▶ **FILE #:** 12-D-13-UR

▶ **APPLICANT:** WALNUT STREET GARAGE, LLC

▶ **PROPOSED USE:** Parking garage

▶ **APPROVE** the request for the multi-story parking garage as shown on the development plan subject to 7 conditions

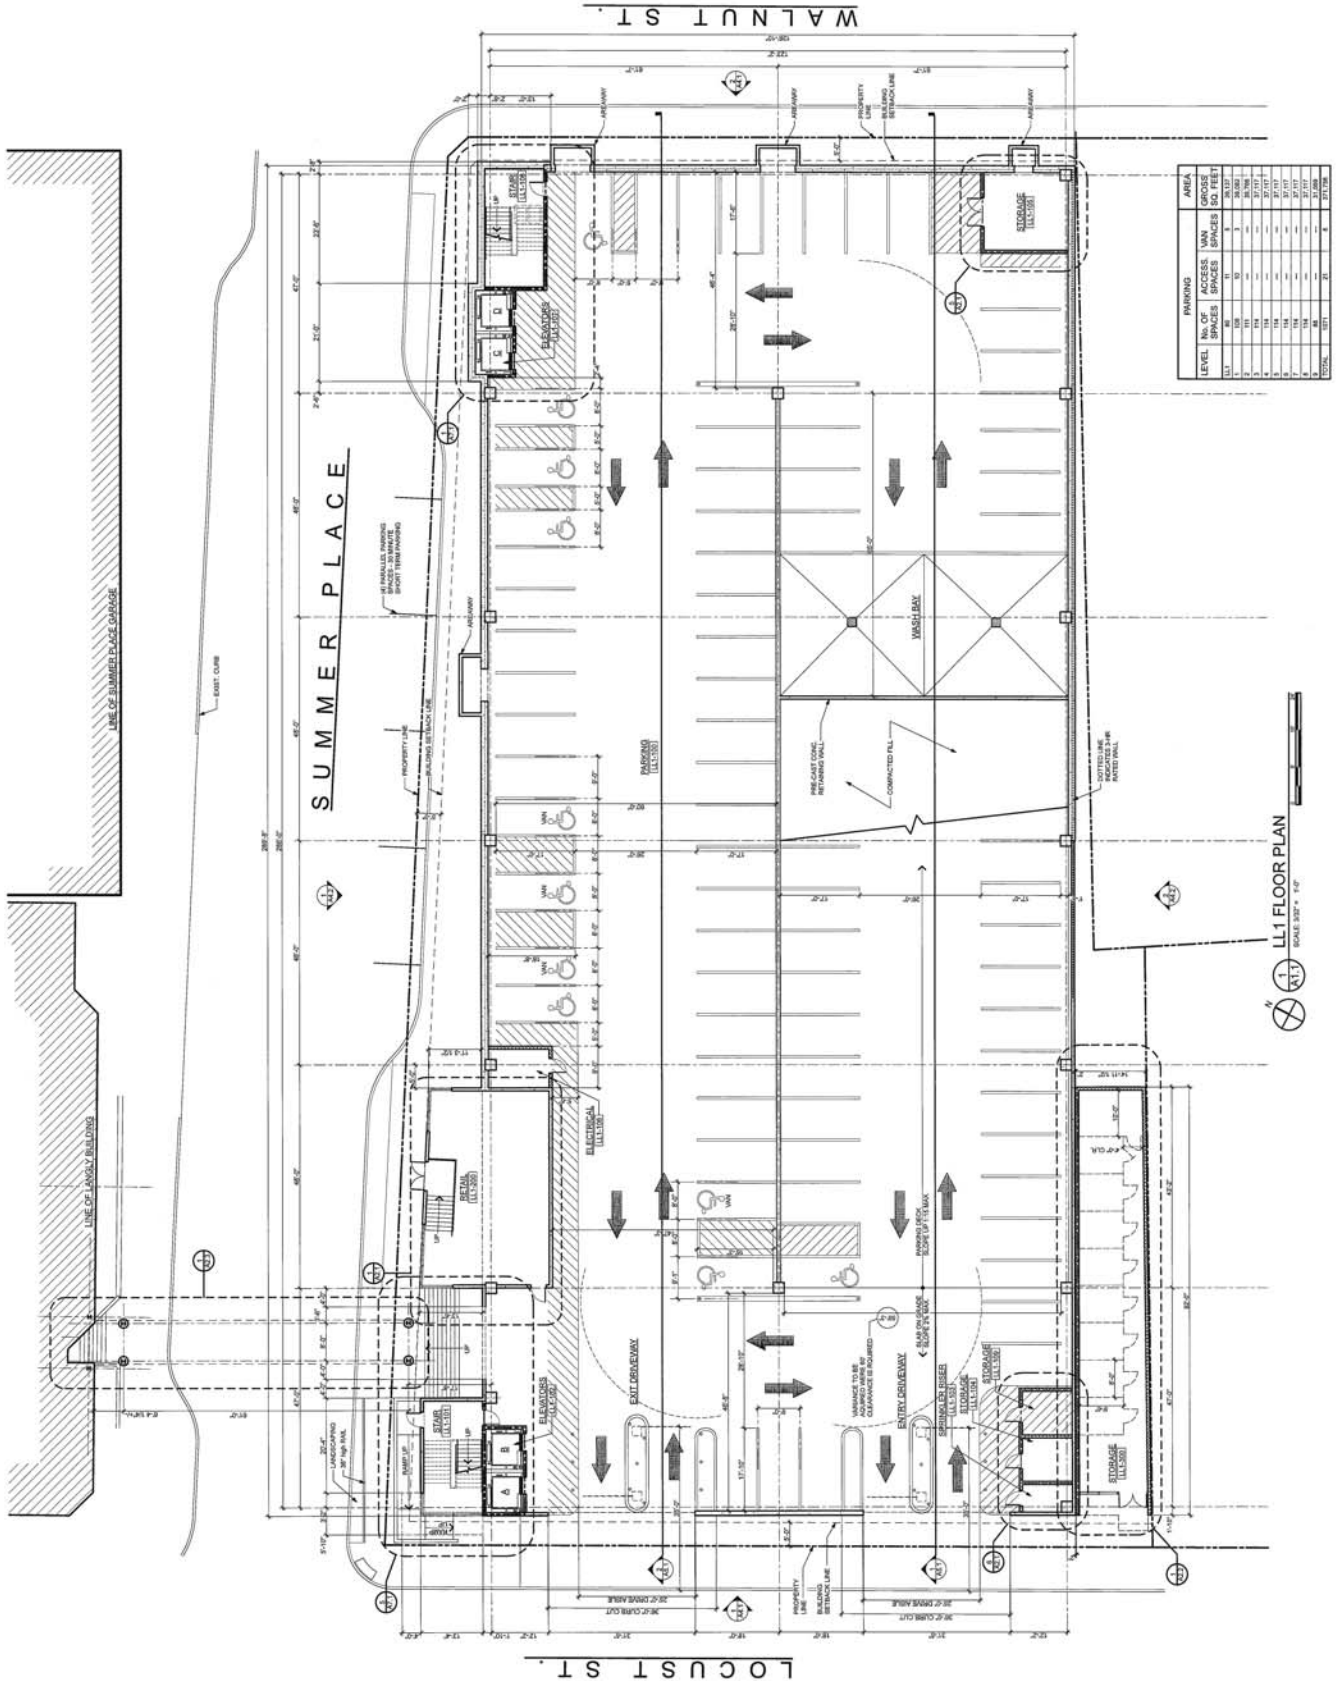
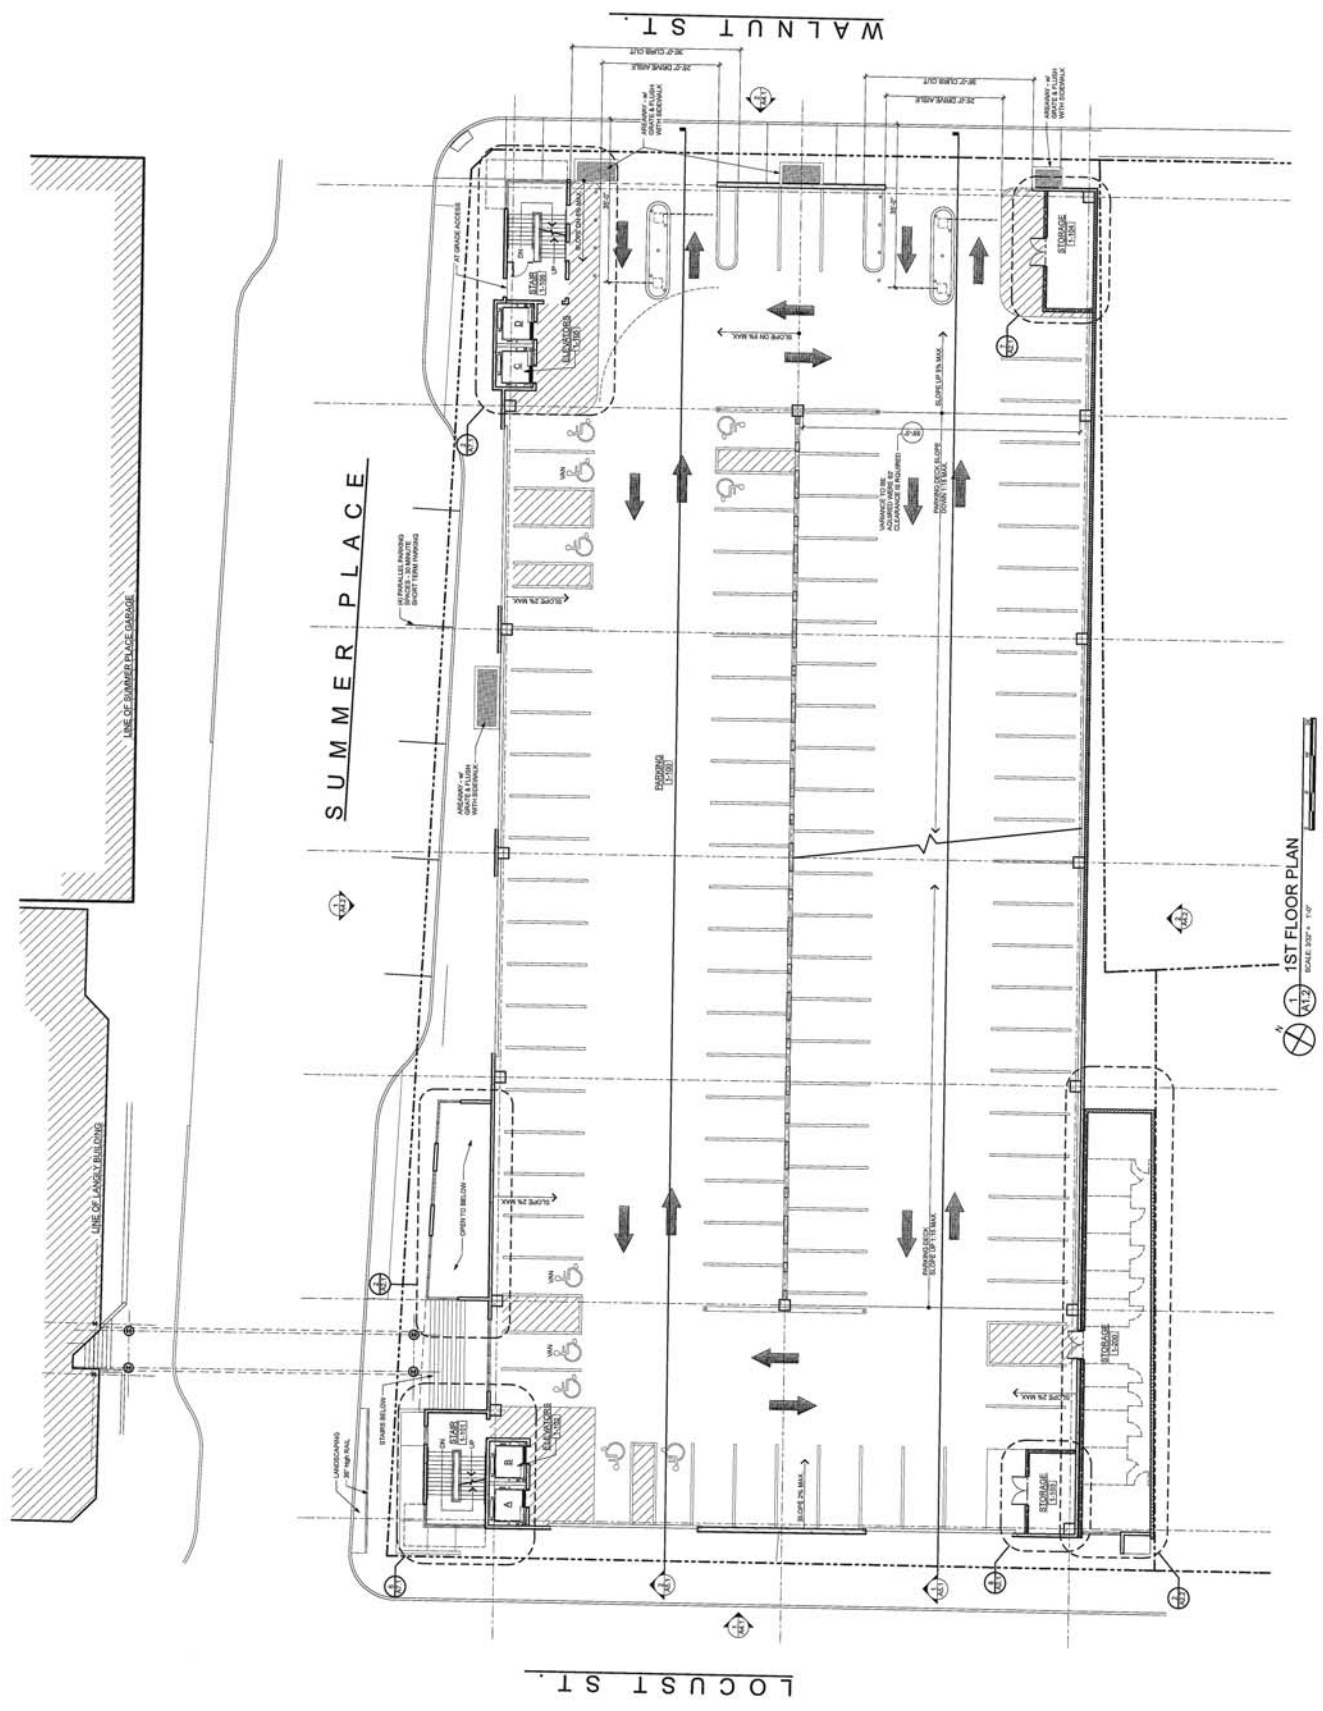
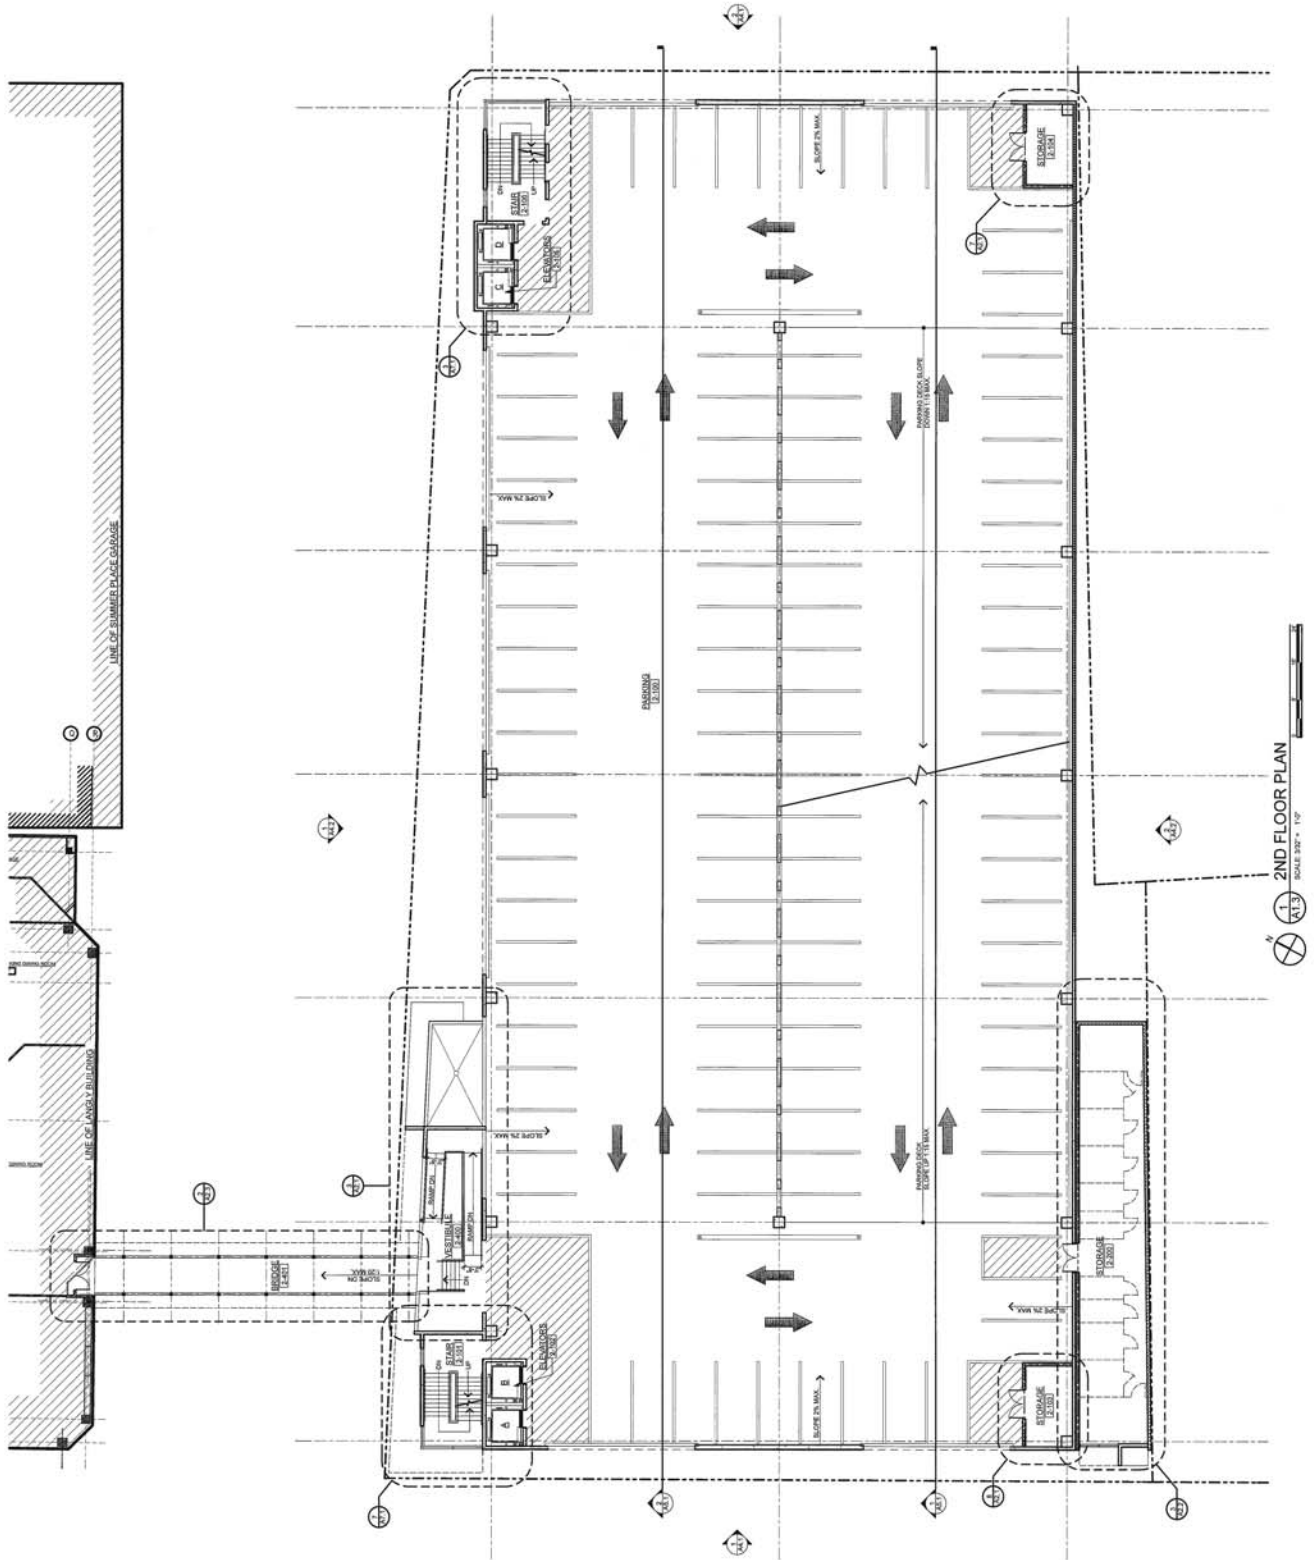
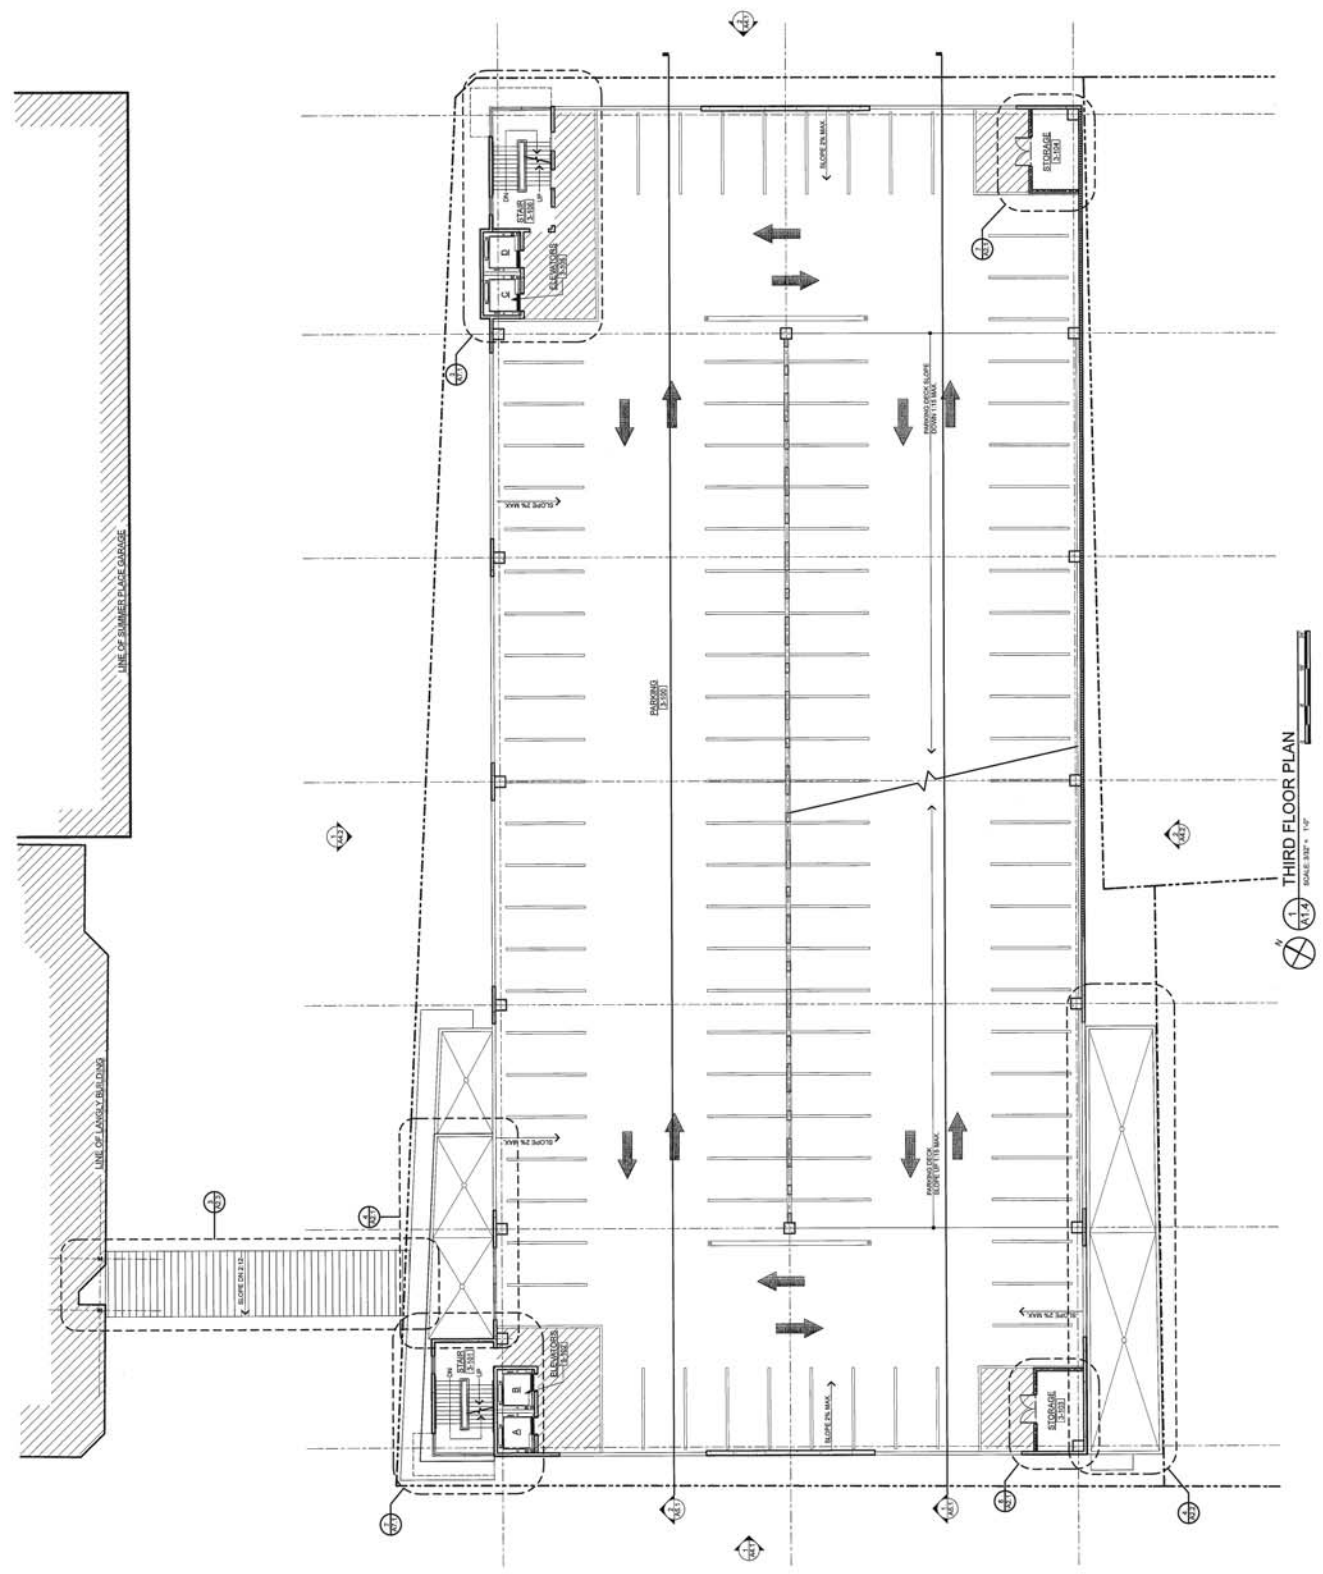
Staff is recommending that the parking layout on the first floor parking level be revised by removing 10 parking stalls on the south side of the two-way drive aisle that leads to the entrance/exit onto Walnut Street at the northeast corner of the building. This area shall be converted into a bypass lane to allow vehicles to get around vehicles stacking in the exit lane at the first exit so that they can continue to the other three exits. If the change is not made, as designed, the entrance/exit onto Walnut Street at the northeast corner of the building has the potential of holding up exiting traffic for approximately 968 of the 1071 parking stalls in the garage.

2. Meeting all other applicable requirements of the Knoxville Zoning Ordinance or obtaining any required variances.
3. Revising the parking layout on the first floor parking level by removing 10 parking stalls on the south side of the two-way drive aisle that leads to the entrance/exit onto Walnut Street at the northeast corner of the building. This area shall be converted into a bypass lane to allow vehicles to get around vehicles stacking in the exit lane at the first exit so that they can continue to the other three exits. Internal signage shall also identify that there are additional exits beyond the first exit. (See comments below.)
